RFT 22.019 CfT 8642316
Query Response Sheet No. 8
RFT 22.019 Invitation to Tender for the Construction of a New TwoStorey Tertiary Education Building Extension at Drogheda Institute of Further Education for LMETB

This query response sheet contains responses to queries received up to (16.00) hours on 24/08/2026).

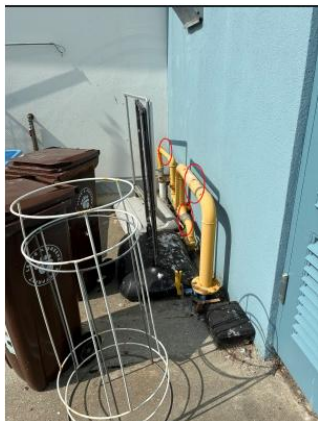
Mechanical Control Wiring, the contractor is to allow for gas meters along with cabling back to the BMS on the gas supply to each gas fired appliance (i.e. gas fired water heater and boilers) in each Plantroom along with 3no. gas meters located externally outside the Existing Plantroom as shown in the below image.
